309 KING STREET NEWCASTLE

COUNCIL RFI - SOLAR

25 JUNE 2025

CONTENTS
SOLAR ACCESS COMPLIANCE RESPONSE

APARTMENT TYPOLOGY SOLAR ANALYSIS - TOWER B UNIT 510 1HR.45MIN BALCONY

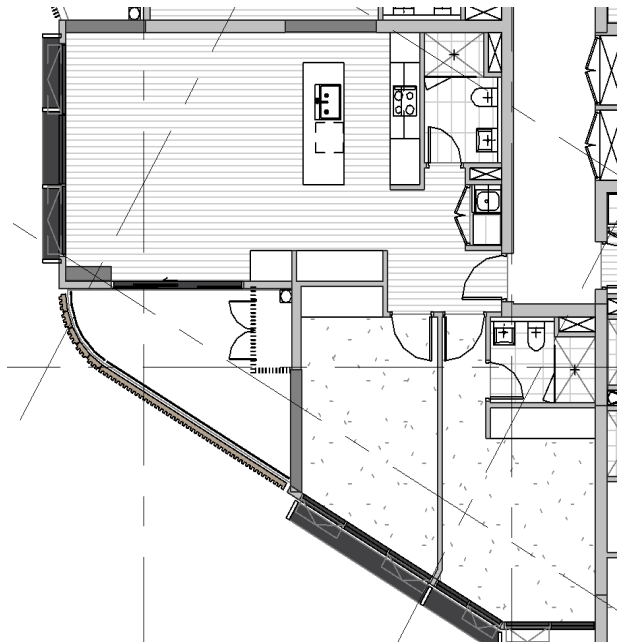
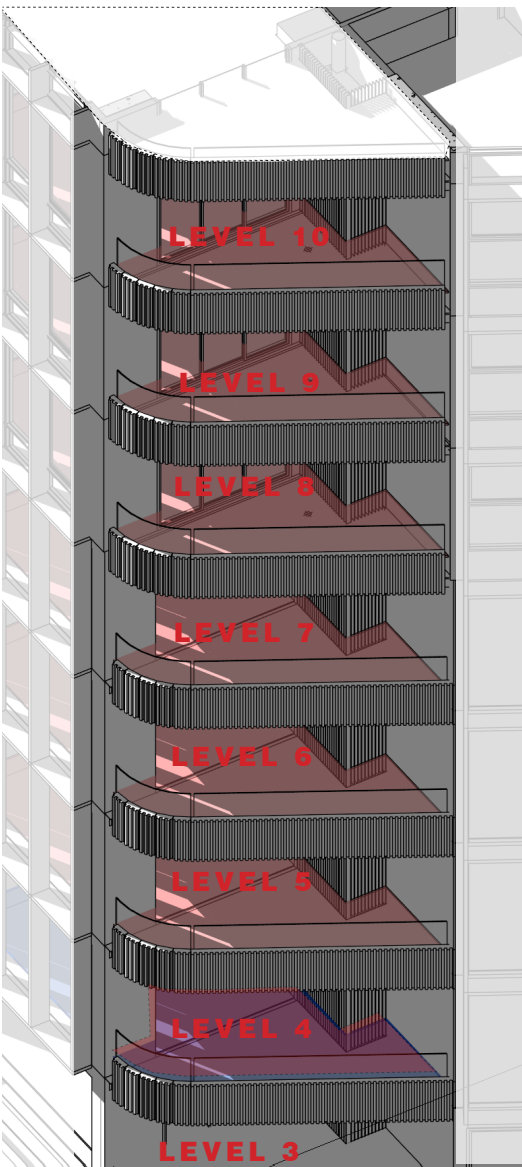
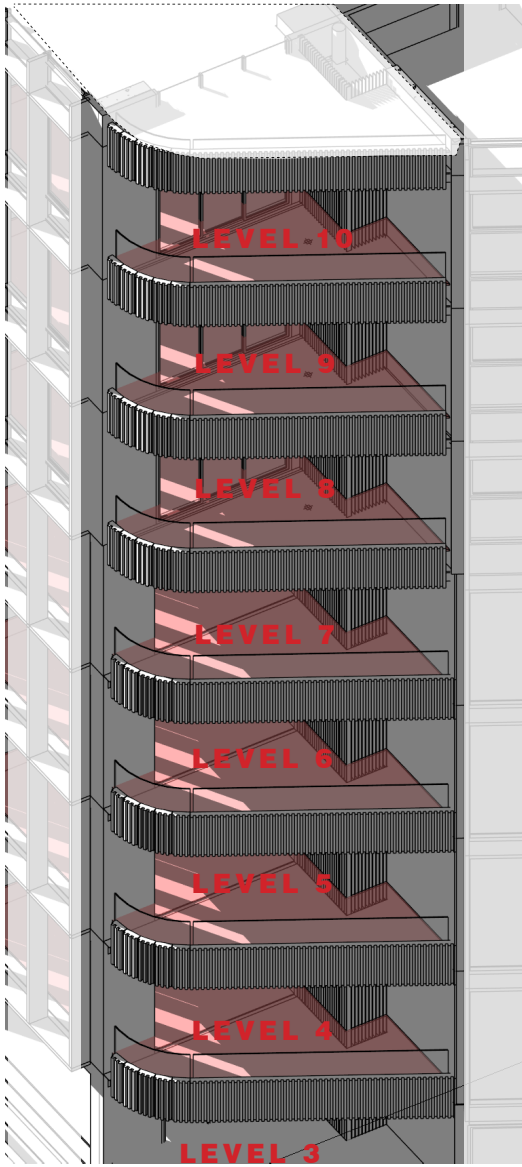
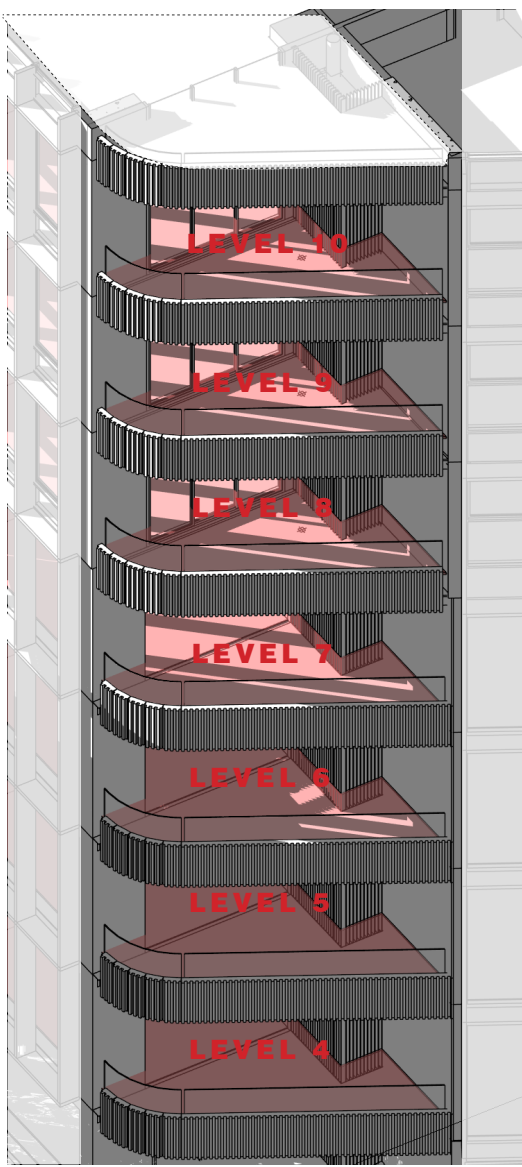
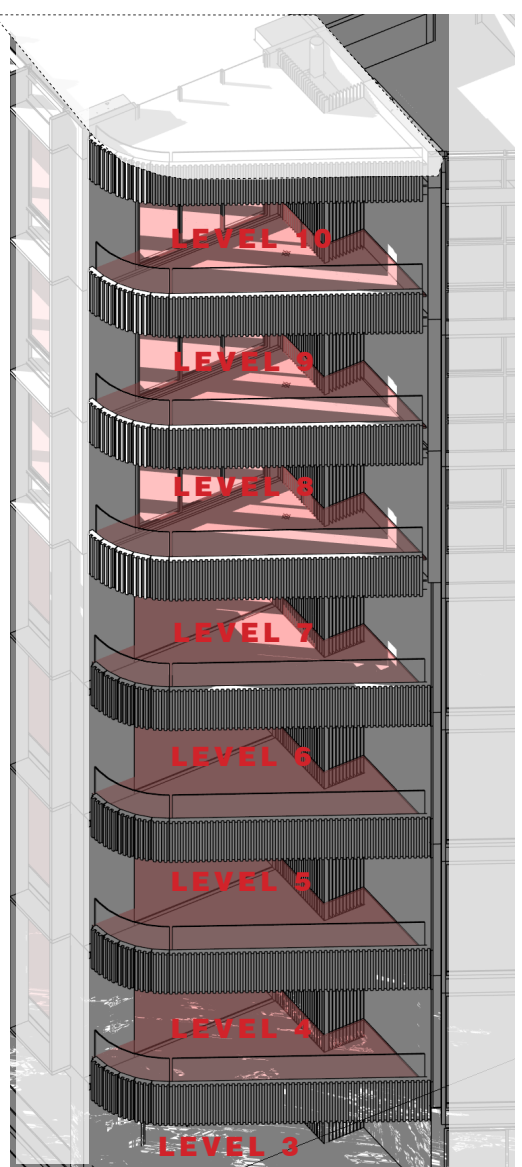
COUNCIL COMMENTS - 410B TO 810 B IS INCLUDED IN APPLICANT'S <1HR 45MIN CALCULATION, HOWEVER CN ASSESSMENT WAS UNABLE TO CONFIRM SOLAR ACCESS TO THE BALCONY. ACCORDINGLY, IT IS NOT INCLUDED IN CN'S <1HR 45MIN CALCULATION

RESPONSE - SUNLIGHT TO BALCONY PASSES THROUGHT THE LIVING AREA.

LEVEL 1 TO 5 - <1HR 30 MINS - 11.55AM - 1.00 PM

LEVEL 6 - 8 - 1HR 30MINS - 11.55 AM - 1.30 PM

APARTMENT TYPOLOGY SOLAR ANALYSIS - TOWER B UNIT 910 - 1HR.45MIN BALCONY

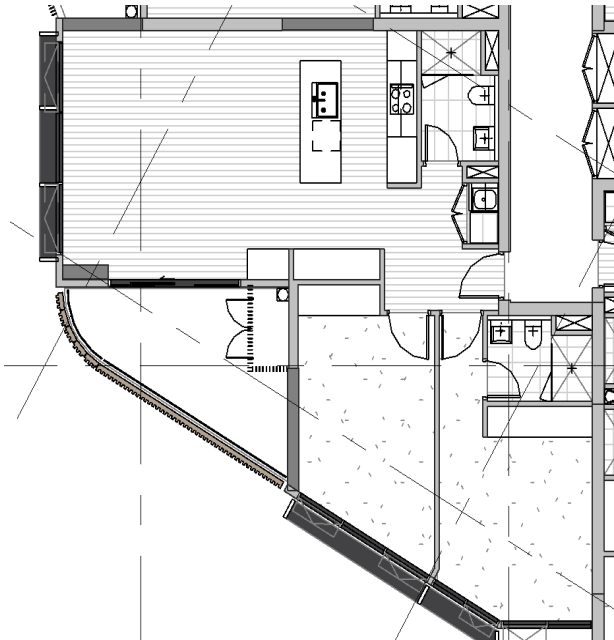
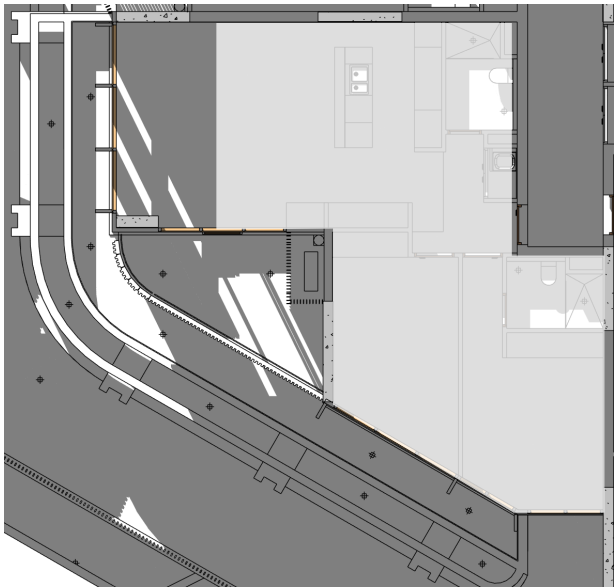
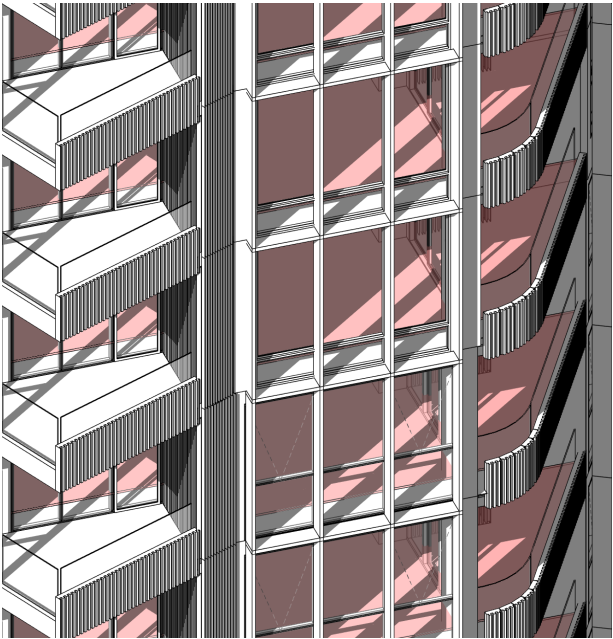
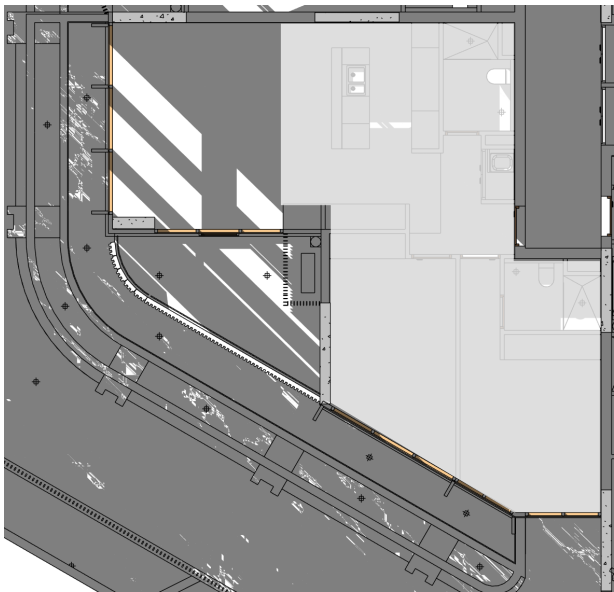
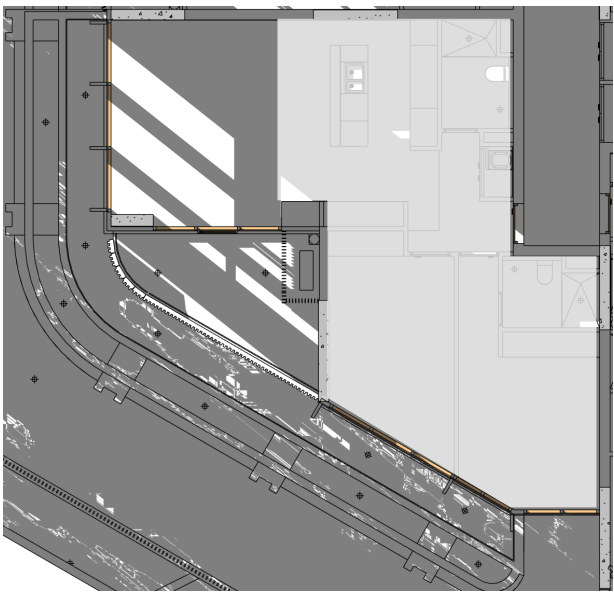
COUNCIL COMMENTS- LEVEL 9 - 14 - CN ASSESSMENT 15MINS
RESPONSE
LEVEL 9 - 1HR 45 MINS - 11.55 AM - 1.45 PM
LEVEL 10 - 14 - > 2HRS - 11.55 PM - 3.00 PM

APARTMENT TYPOLOGY SOLAR ANALYSIS - TOWER B - UNIT 501 - 1HR.40 MINS

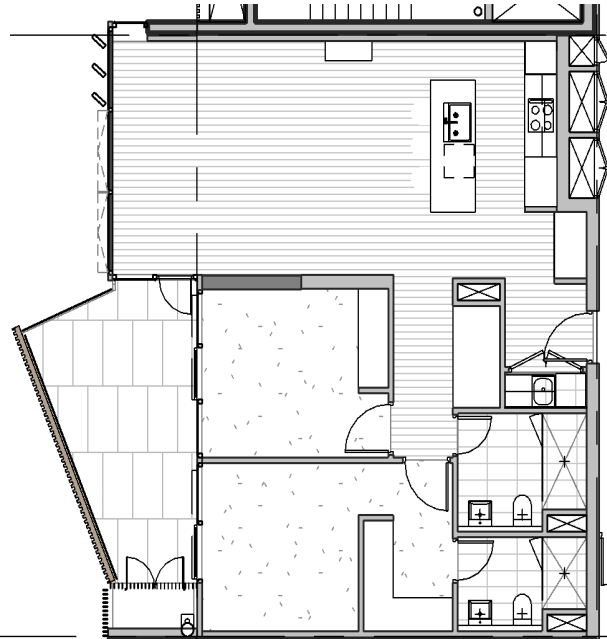
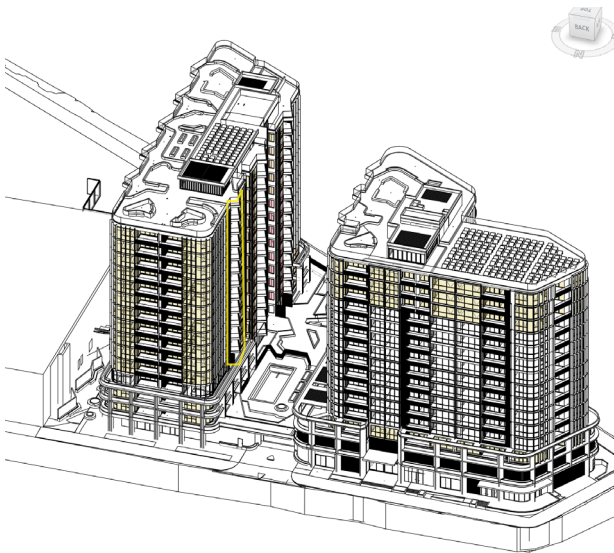
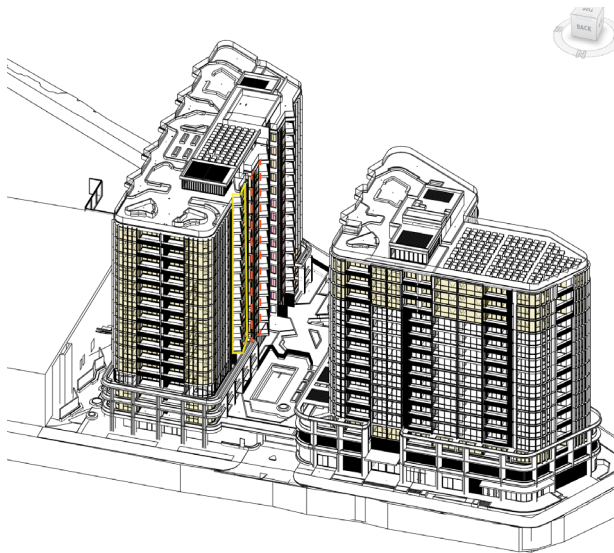
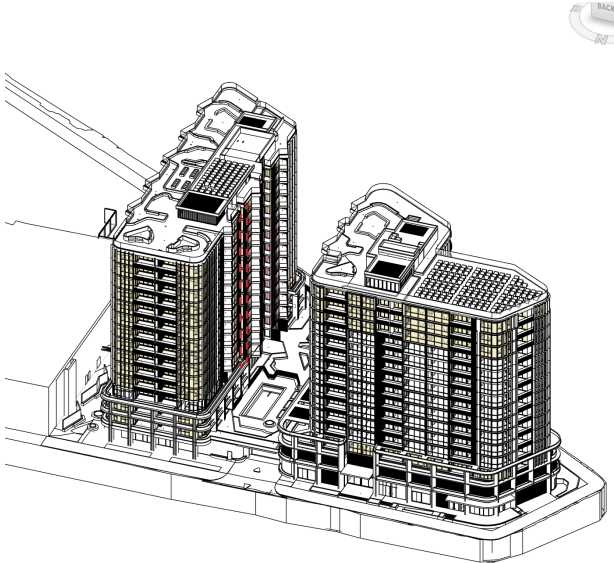
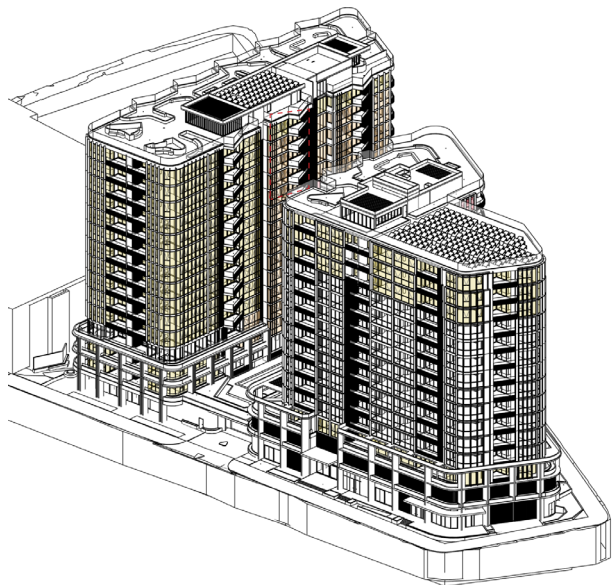
COUNCIL COMMENTS - LEVEL 6 -9 - CN ASSESSMENT:1HR 45MINS
RESPONCE

LEVEL 1 - 9 - 1HR.40 MINS - 12.20PM TO 2.00PM

LEVEL 10 - 14 - 2 HRS W

AT 12.15 THE BALCONY ANGLE
OVERSHADOWS THE FACADE AND STOPS
SUNLIGHT ENTERING INTO THE LIVING
AREA. SUNLIGHT AREA~0.85SQ.M

AT 12.20 THE SUNLIGHT WITHIN THE
LIVING ROOM INCREASES TO ~1.03SQ.M
AT 12.30 ~1.45SQ.M

AT 2.15 TOWER A OVERSHADOWS UNITS IN
LEVEL 02-09.

APARTMENT TYPOLOGY SOLAR ANALYSIS - TOWER A UNIT 501 -1HR.30MINS

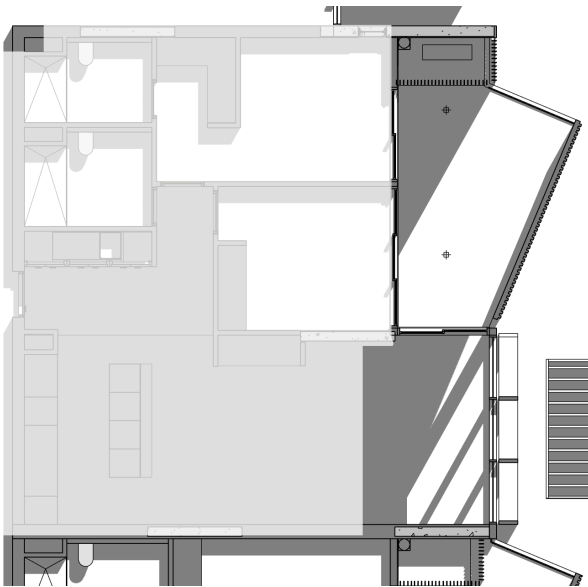
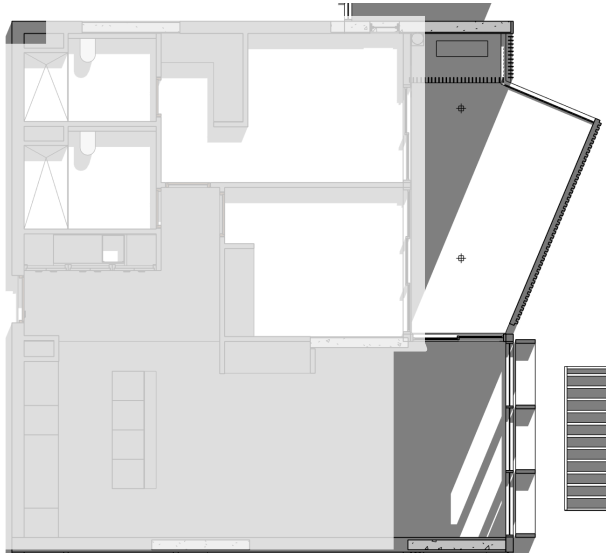
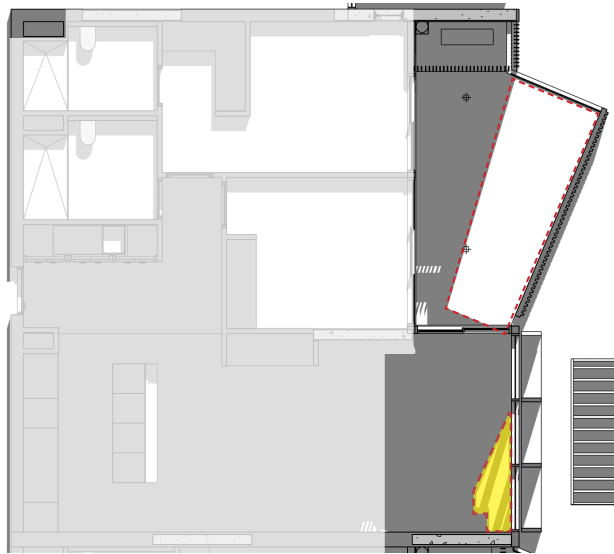
COUNCIL COMMENTS - 201A AND 202A ARE INCLUDED IN APPLICANT’S < 1HR 45MIN CALCULATION, HOWEVER CN ASSESSMENT WAS UNABLE TO CONFIRM SOLAR ACCESS TO THE LIVING ROOMS DUE TO AWNING STRUCTURE OVER. ACCORDINGLY, THEY ARE NOT INCLUDED IN CN’S < 1HR 45MIN CALCULATION

LEVEL 3 - 14 - COUNCIL COMMENTS -CN ASSESSMENT:1HR 30MINS

RESPONCE - LEVEL 2 - <1HR.30 MIN

RESPONCE - LEVEL 3 - 14 - 1HR.30MINS

DAYLIGHT ANALYSIS -10.30 AM
LIVING ROOM ~ 1.4 SQ.M
BALCONY - 7.1 SQ.M

DAYLIGHT ANALYSIS -10.45 AM
LIVING ROOM ~ 0.48 SQ.M
BALCONY - 6.35 SQ.M

APARTMENT TYPOLOGY SOLAR ANALYSIS - TOWER A UNIT 503 - 1HR.30MINS

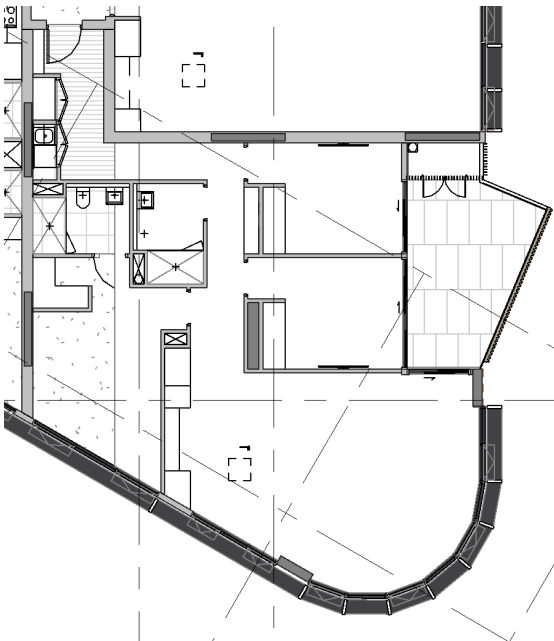
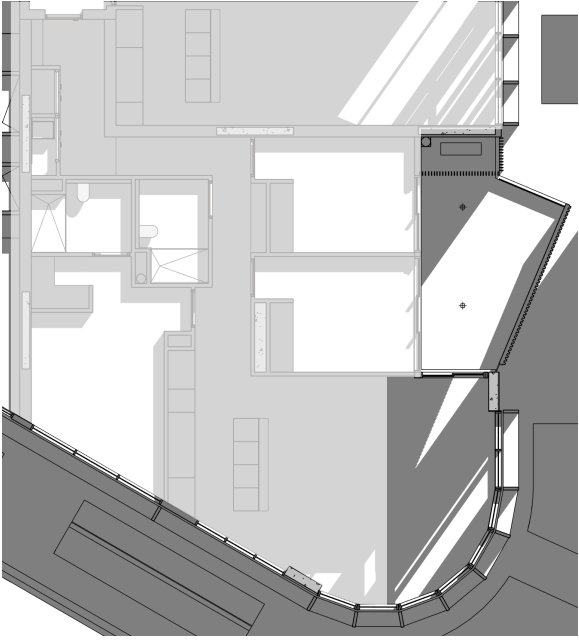
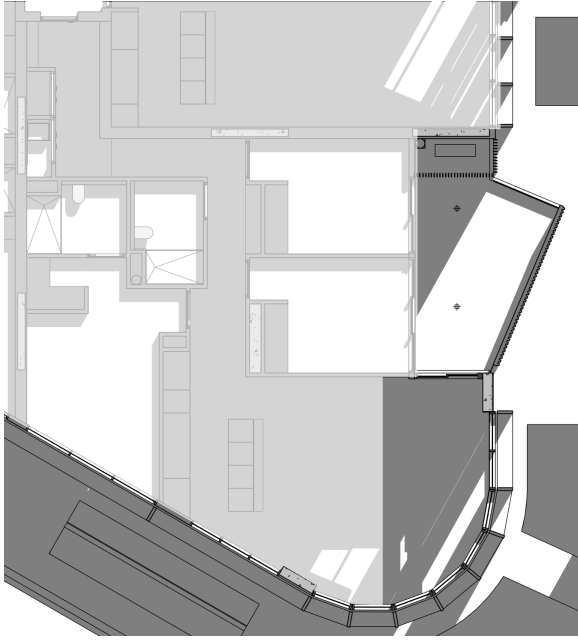
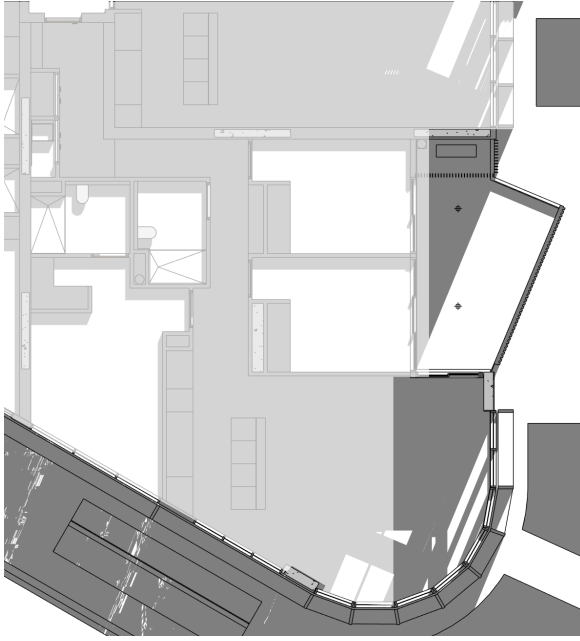
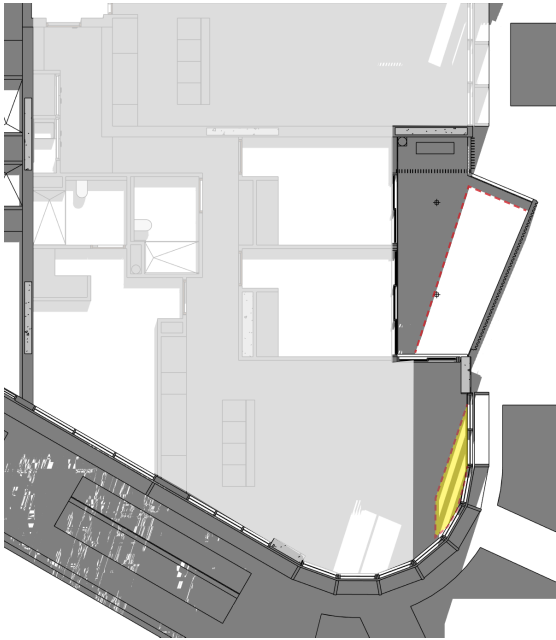
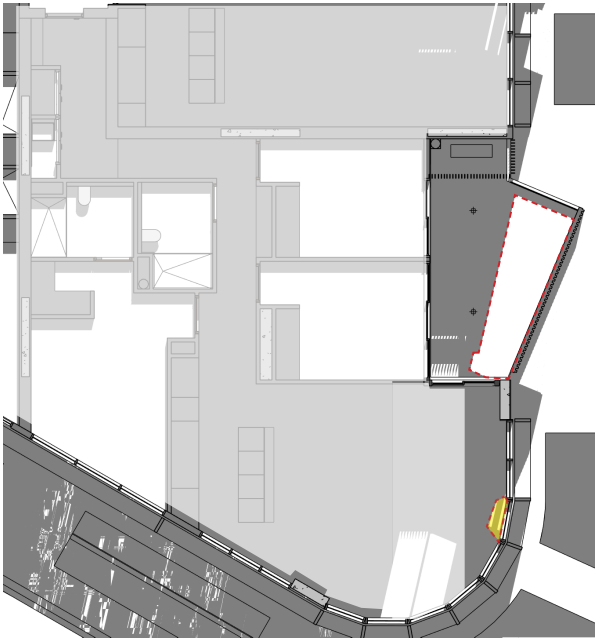
COUNCIL COMMENTS - CN ASSESSMENT:1HR 30MINS
RESPONSE
LEVEL 2 - <1HR.30 MIN
LEVEL 3 - 14 - 1HR.30MINS

DAYLIGHT ANALYSIS -10.30 AM
LIVING ROOM ~1.35 SQ.M
BALCONY - 7.18

DAYLIGHT ANALYSIS -10.45 AM
LIVING ROOM ~0.25 SQ.M
BALCONY - 5.82 SQ.M
